NOTICE OF A TYPE II DECISION ON A PROPOSAL IN YOUR NEIGHBORHOOD

CASE FILE NUMBER: LU 08-155601 DZ - REVISIONS TO PREVIOUSLY APPROVED DESIGN REVIEW FOR MAX SOUTHERN TERMINUS

Proposal: The applicant requests Design Review approval for revisions to a previous Design Review, LU 08-103190 DZ, which approved the construction of the southern terminus of the new MAX light-rail alignment through downtown Portland. The proposed revisions include the following:

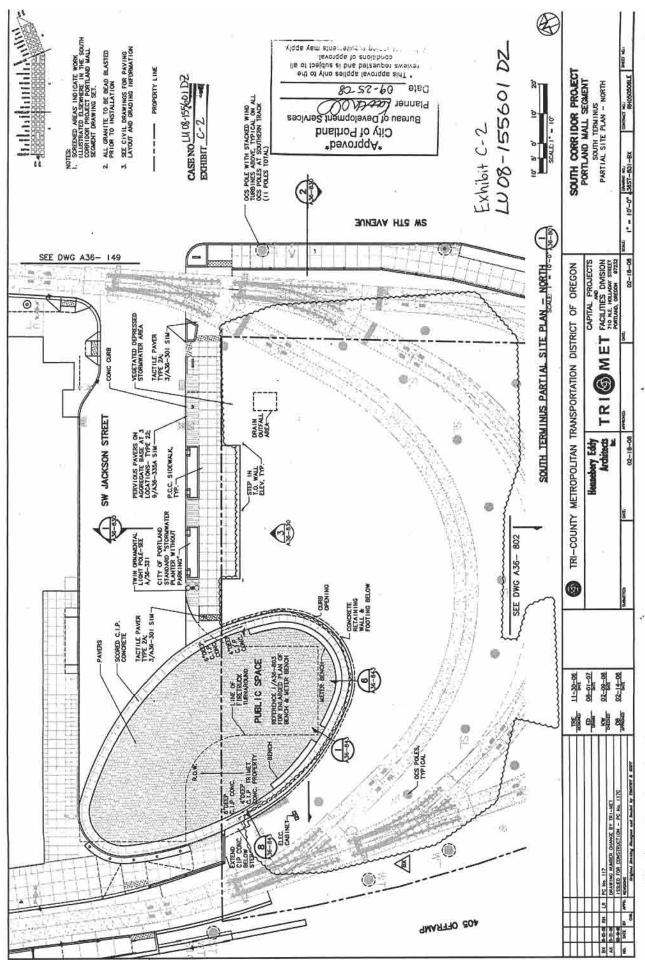
- The previous Design Review approved gabion landscape walls within the stormwater infiltration swale, and at edges of the swale. The gabion walls are now proposed to be removed from the design.

- The previous Design Review approved a depressed stormwater infiltration swale. The stormwater infiltration swale is now proposed to have a terraced pattern, sloping up at the edges of the swale where gabion walls had previously been planned.

- The previous Design Review approved a retaining wall composed of re-claimed granite around the fire truck turn-around/public plaza. The retaining wall is now proposed to be made of re-claimed concrete "K-rails" (also known as "jersey barriers").

- The previous Design Review approved at-grade up-lights at the perimeter of the fire truck turn-around, where it meets the stormwater infiltration swale. These light fixtures are now proposed to be removed from the design.

- The previous Design Review approved overhead catenary system (OCS) poles each with two metal halide down-lights, bordering the light-rail tracks. These OCS poles are now proposed to each have one metal halide downlight.

- Terraced stormwater swale instead of a depressed stormwater swale,
- No gabion walls in the stormwater swale,
- No at-grade up-lights at the perimeter of the fire truck turn-around/public plaza,
- K-rails instead of granite for the retaining wall around the fire truck turn-around/public plaza, and
- One light fixture instead of two on each OCS pole bordering the light-rail tracks.
